Application for Approval of a Certificate of Public Convenience and Necessity for the A.S. Mawdsley Terminal Station Project (Application) ~ Project No. 1599424

Response to the British Columbia Public Interest Advocacy Centre representing BC Old Age Pensioners' Organization, Active Support Against Poverty, Council of Senior Citizens' Organizations of BC, Disability Alliance BC, and Tenant Resource and Advisory Centre (BCOAPO) Information Request (IR) No. 1

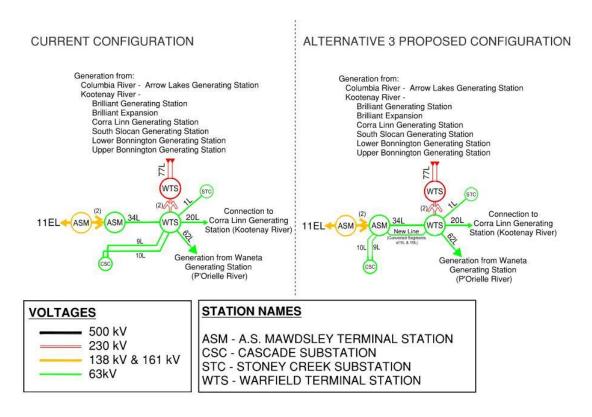
10.2 Please provide an expanded version of Figure 3-2 that shows the Cascade Substation and the current (as well as the new) positions for the 9 Line and the 10 Line.

The following diagram shows the current configuration of WTS, including transmission to Cascade Substation (CSC), and the proposed reconfiguration under Alternative 3.

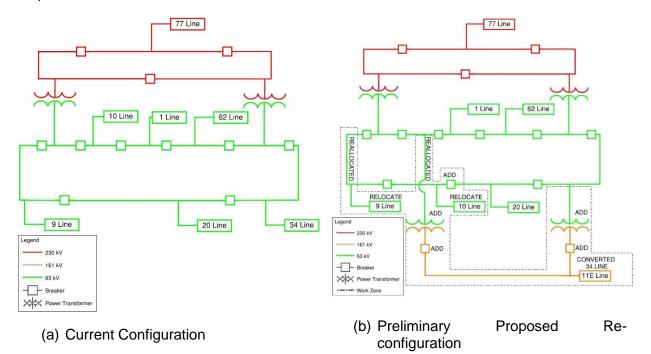
11.0 Reference: Exhibit B-1, pages 12 (Figure 3-2) and 28 (Figure 4-4)

11.1 Figure 3-2 only shows Lines 34L, 20L, 62L and 77 L as connecting to WTS. In contrast, under the existing configuration, Figure 4-4 also shows Line 1, Line 9 and Line 10 as connecting to WTS but not Line 34L. Please reconcile.

- In the Application, Figure 3-2 was simplified to only show transmission lines relevant to the supply to the Boundary and Similkameen areas and their connection to generation (as explained in Footnote 2 of the Application). Please refer to the response to BCOAPO IR1 10.1 for the expanded Figure 3-2 with all WTS transmission connections.
- FBC notes that 34 Line was inadvertently excluded from Figure 4-4 (a) in the Application. The diagram below provides the corrected Figure 4-4 with 34 Line included in Figure 4-4 (a). No correction to Figure 4-4 (b) is required, however, FBC has included Figure 4-4 (b) for completeness.
